Mounting Instructions

Retrofit Brackets [Z-SMA and Z-GMA]

Replacing discontinued Belimo

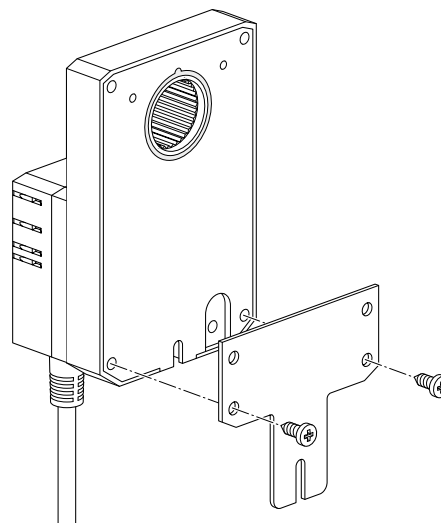
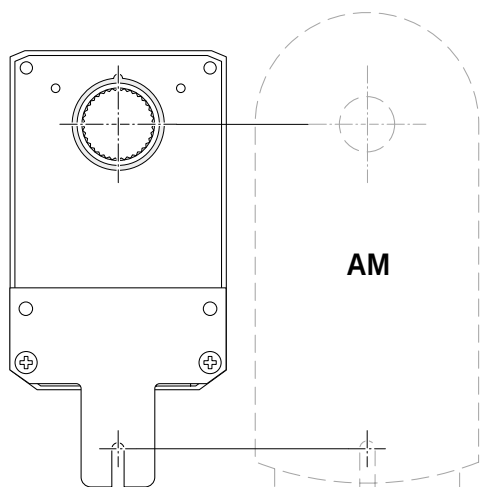
When replacing an actuator, whether Belimo or other, be sure to consider the application parameters before selecting the replacement. The new product may not be the best fit for the application. Example would be a Belimo AM24 US mounted to a valve linkage. The direct replacement of the actuator is AMB24-3. However, the AM24 US and the AMB24-3 are different lengths, the linkage would need to be replaced as well.

Instead of replacing the linkage the retrofit bracket Z-SMA and Z-GMA can be used to extend the location of the anti-rotation bracket to match the location of the anti-rotation bracket of discontinued Belimo actuators.

Z-SMA for replacing AM and SM actuators
Z-GMA for replacing GM actuators
